EL PASO COUNTY DEPARTMENT OF HEALTH AND ENVIRONMENT
INDIVIDUAL SEWAGE DISPOSAL SYSTEM INSPECTION FORM

Permit # 10709
Date 10-31-96

Address 53 Marland Rd Owner Hexox

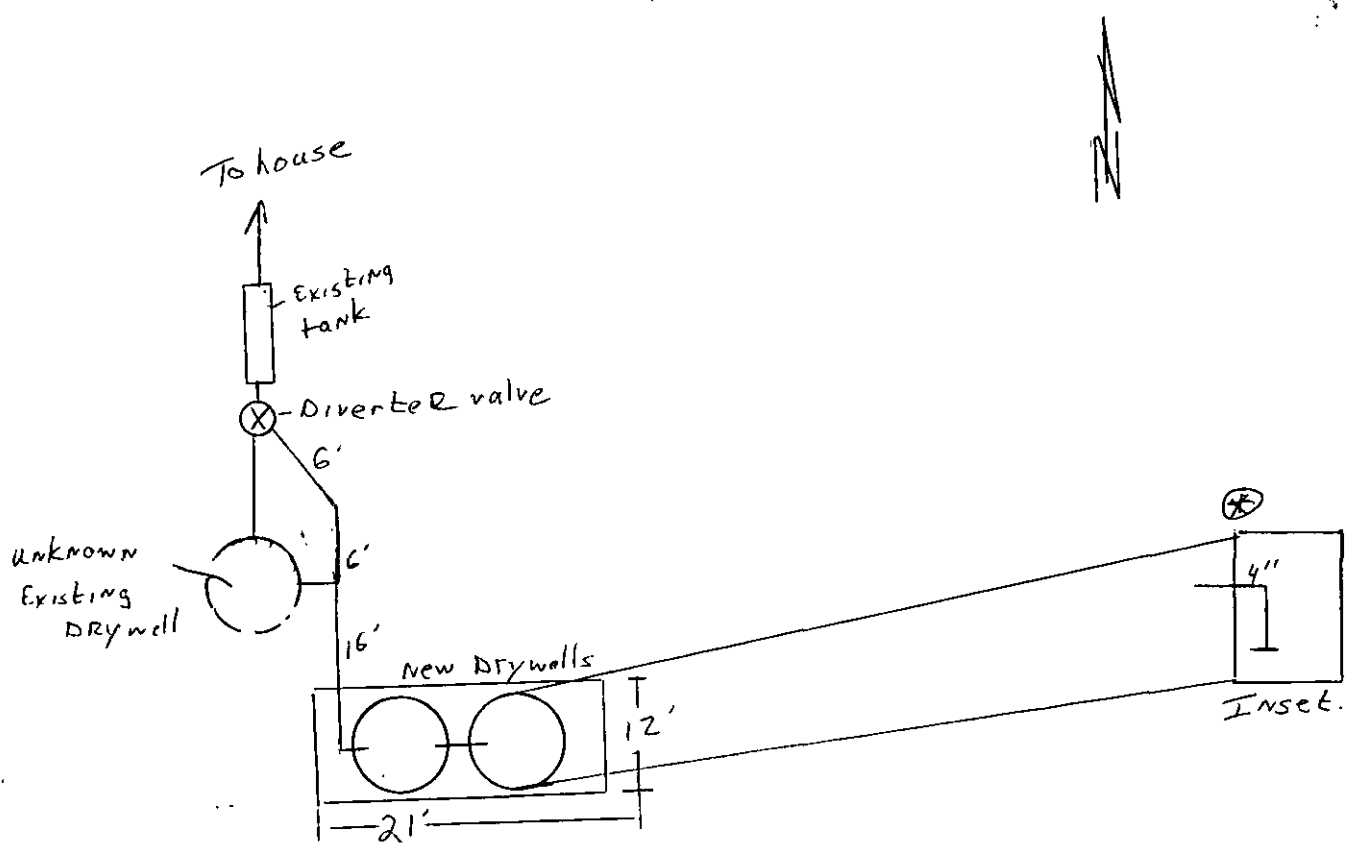
NOTES:
⊗ Vertical standpipe with tee fitting installed in both pits for drywell application.
used 6'-7' concrete rings - only gave credit for 4 rings. due to inlet pipe entering the 2nd ring below grade
